Appendix B

Stormwater

RE: PROPOSED DEVELOPMENT FRASER DRIVE MP06- 0243

Further to your summary of submissions letter dated 20 August 2007, we comment on the issues you raise in terms of water quality as follows:

SKETCH No. 16 (18/12/07)

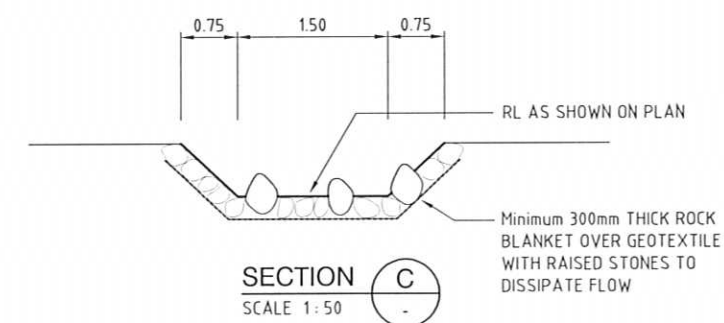
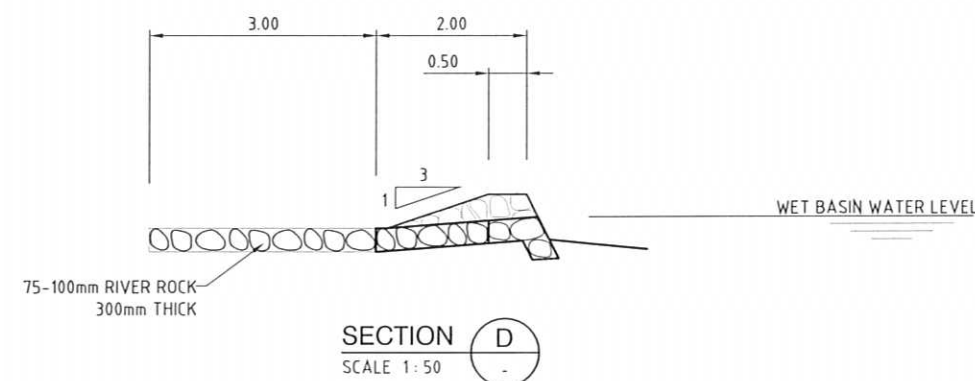
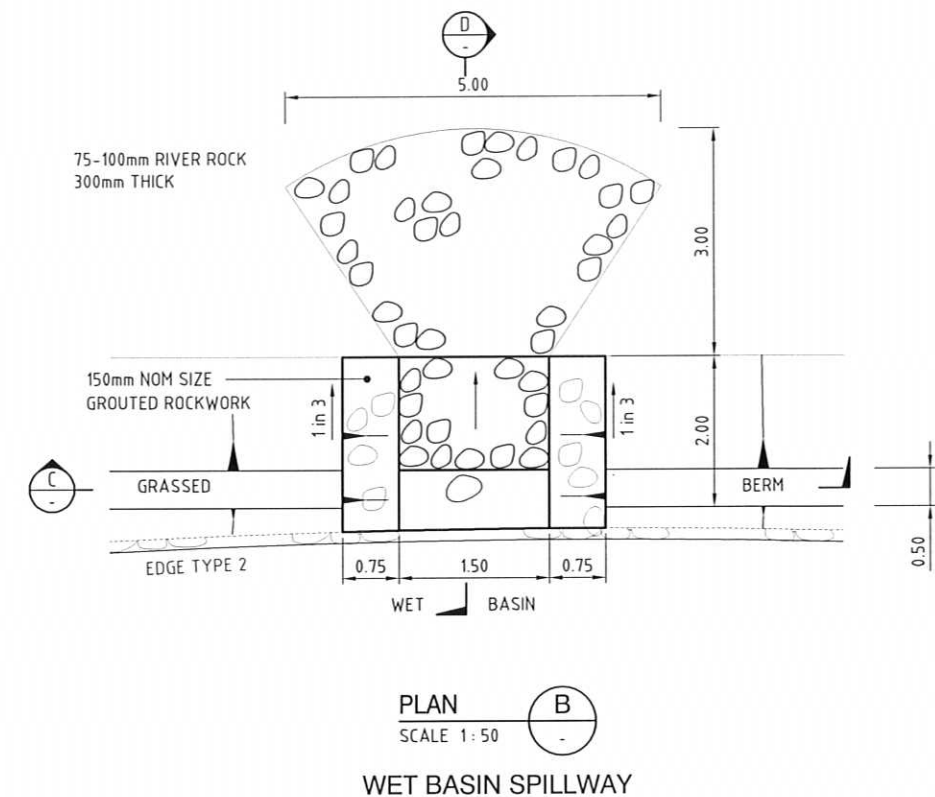
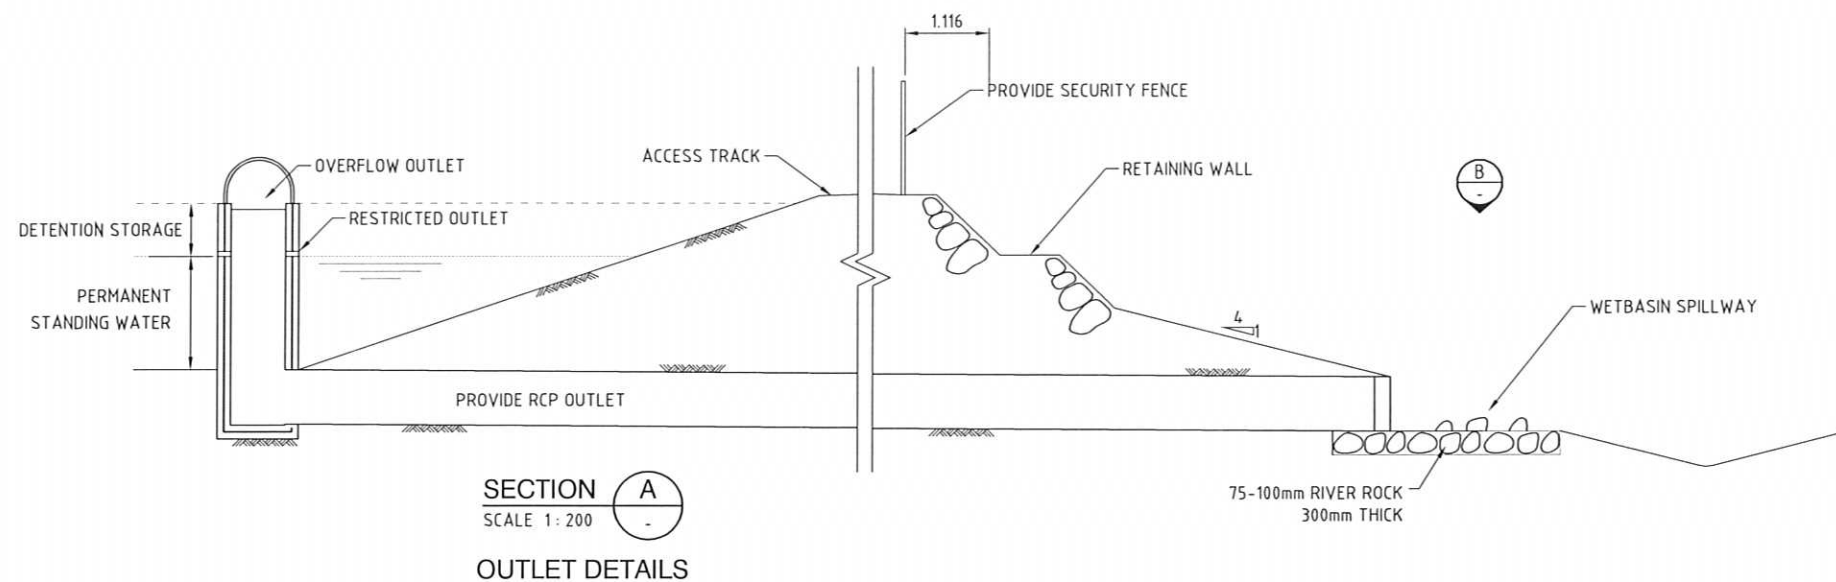
- 35. Provide preliminary design for outlet control measures for the on site detention pond proposed for Part A of the subdivision, to maintain a hydraulic regime compatible with the receiving SEPP14 wetland.**

- 36. Provide an engineering assessment as to the compatibility of the pond in Part A of the subdivision as a combined water treatment and on site detention device. Required volumes for on site detention must account for standing water levels necessary for water quality control in constructed wetlands. The assessment must consider how the combined device can cater for ARI 100 year storm detention, and water quality measures up to the ARI 3 month storm, without the remobilisation of pollutants under larger flows.**

The outlets will be designed at detailed design phase. Council still have final approval during construction & s68 approvals. Refer attached Sketch SK-016 for typical details.

This is a query relating to detailed design. Council still have final approval during construction & s68 approvals. Similar wetlands that incorporate water quality treatment and detention have been approved and constructed in the Terranora Azure development, located approximately 5 km from the Fraser Drive site. The wetland is designed so the water level remains constant during dry periods, but rises during rainfall events to attenuate the flows leaving the site. Additional storage volume is allowed for in the design of the wetland. See attached pictures of similar wetland located in Terranora.

FIGURE No.DA 19

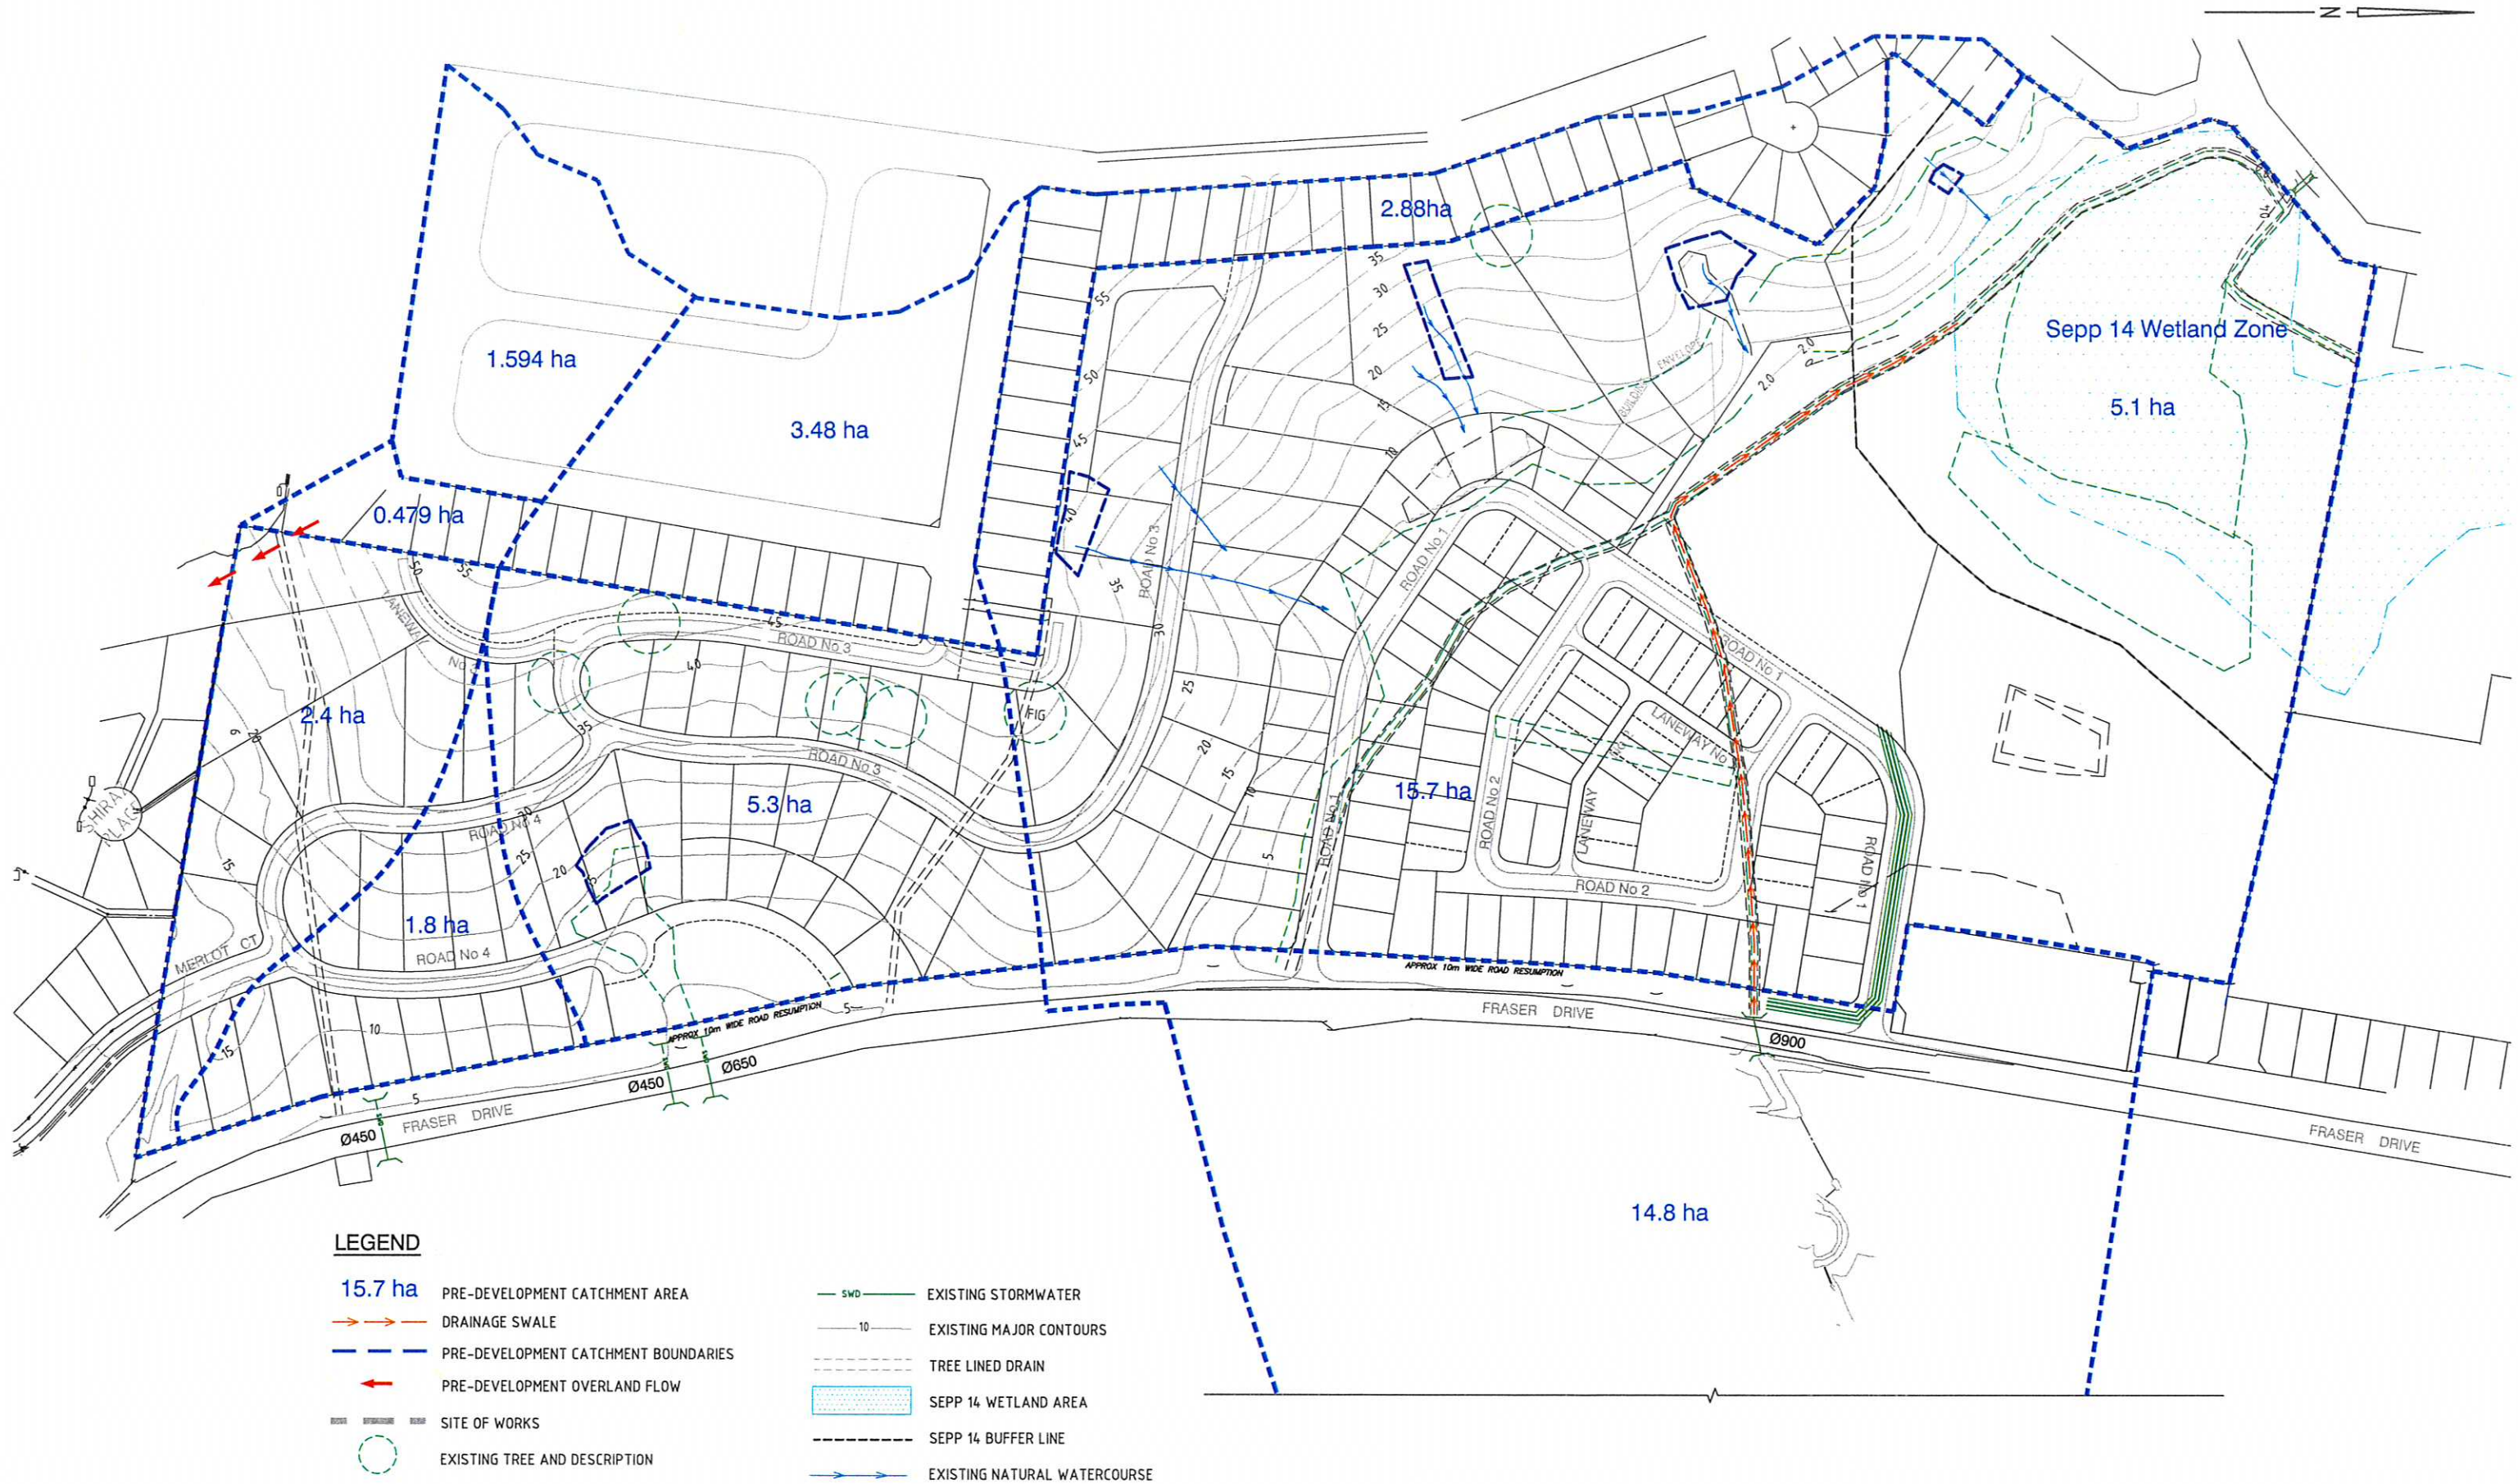
27. Provide design confirmation that the 3 cell 1500mm diameter piped system is adequate to cater for ARI 100 year stormwater runoff from a future urbanised catchment east of Fraser Drive, without resulting in flooding in Fraser Drive. Preliminary design details of Q100 inlet structures shall also be provided.

28. **Amend the design of the 3 cell 1500mm diameter piped system to provide a straighter alignment (eliminating 90 degree bends) between the catchment east of Fraser Drive and the bypass channel for the treatment/detention ponds in Part A of the subdivision, to maximise inlet capacity and minimise the chance of blockage. Further investigation of solutions to the potential conflict between stormwater services and the existing water main in Fraser Drive shall also be provided, to allow for the relocation of the stormwater inlet to the eastern side of Fraser Drive to eliminate the existing 900mm culvert.**

This piped system has been modelled in PC Drain. Any head loss that may occur through the bends has been accounted for in this modelling. Our developer can not impose construction requirements onto another landowner. If Council want the culverts to cross Fraser Drive, then the existing landowners future access and current drive way entrance would have to be moved and the existing drainage path 900 dia culvert would have to be re-routed. It is not reasonable to impose conditions which we can not lawfully impose on another landowner. It is also unreasonable to impose the requirement for the allowance of flows from a developed upstream catchment. Given the requirement for our site to have on site detention to maintain existing peak flows, it should be the responsibility of the upstream property owners to also maintain existing peak flows from their site. Should this condition remain it would be necessary for the applicant to request stormwater headworks credits for any additional infrastructure and loss of land due to allowing for flows greater than the property currently accepts.

Council have previously requested that this site and the site across the road share a common intersection for access to Fraser Drive. The entrance to this site was placed in accordance with Council's recommendation. As the stormwater pipes are located under the roadway due to their size, it makes it impossible to align the stormwater line perpendicular to Fraser Drive without affecting opposite properties driveway access, or possible future development. Even placing pipes under Fraser Drive at a 45 degree angle to the road would require earthworks in the opposite property to change the existing overland flowpath, and re-grade it to the new culvert crossing.

FIGURE No.DA20

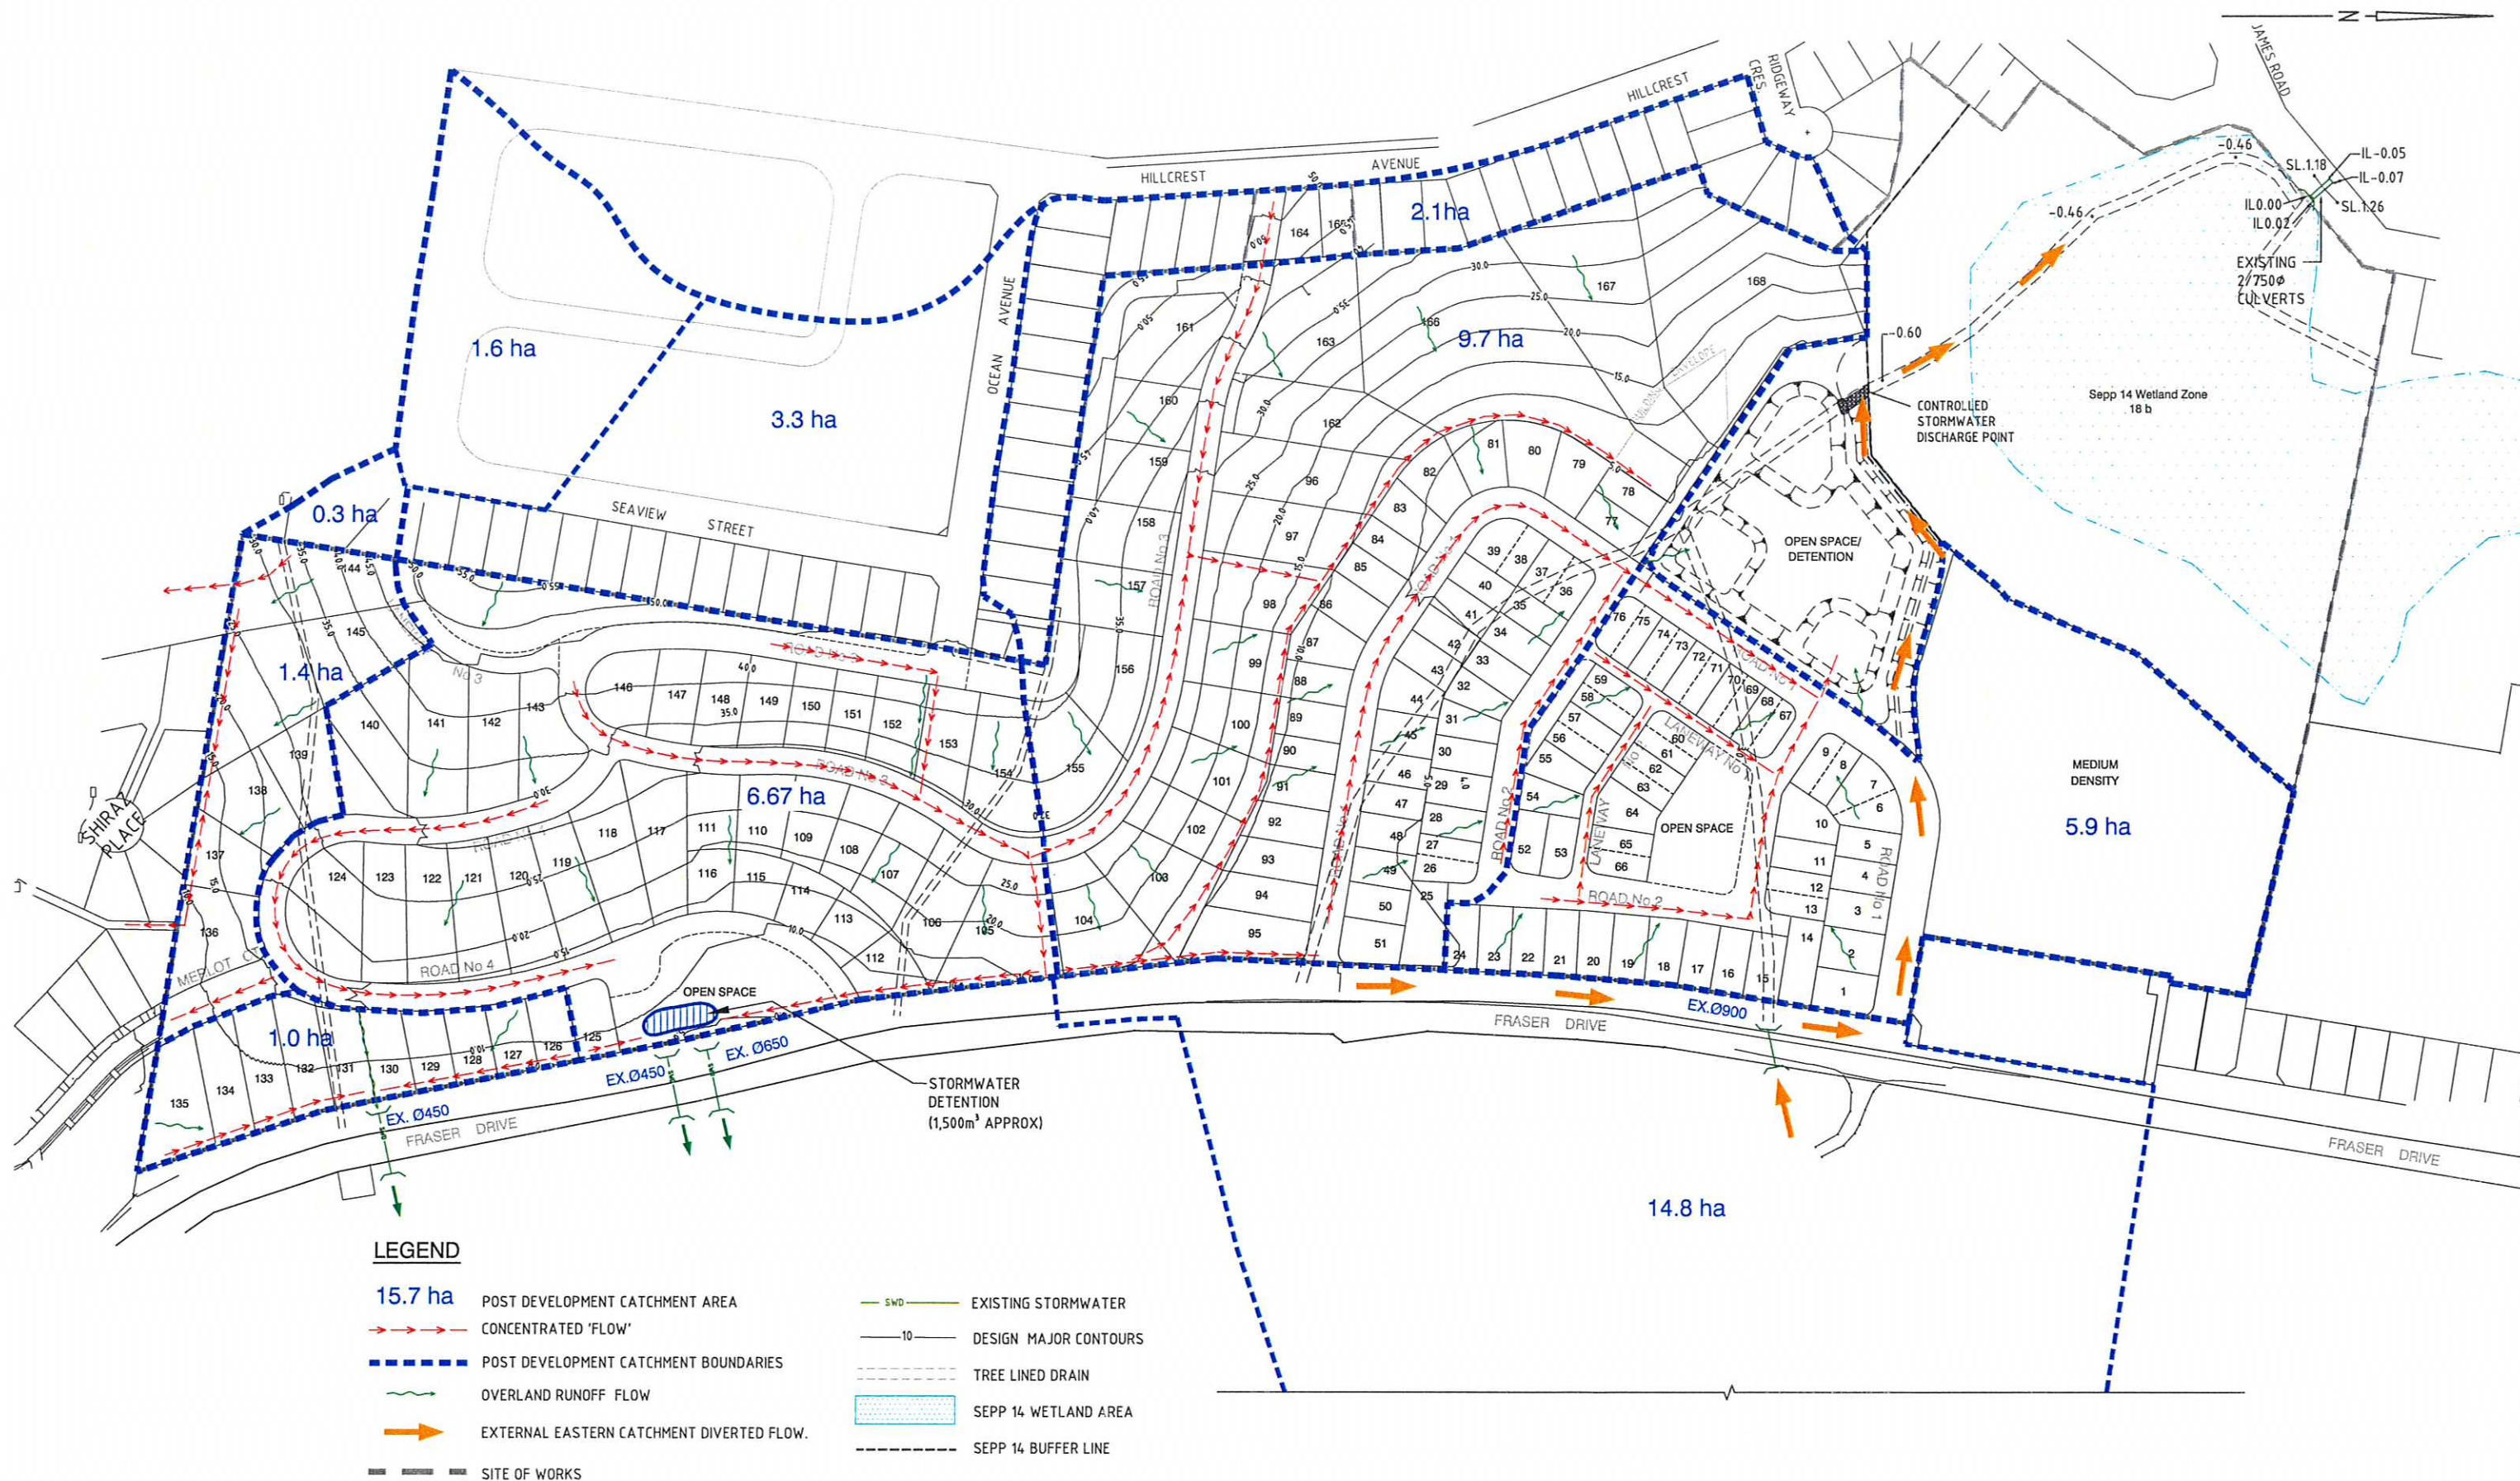
- 33. Provide an assessment of the existing cross sectional capacity of the open channel through the SEPP14 wetland, downstream of the subdivision. This assessment shall include a design and plan of works to upgrade this channel as necessary to cater for post development flows from the subdivision.**

The existing drain, by survey, has no capacity. It grades up hill and in some places is over 0.5m lower than outlet at James Road. See Figure DA 20 which shows levels. The regime is to maintain existing flows into the channel and wetland by detention control. The channel should remain unchanged to maintain ecological balance.
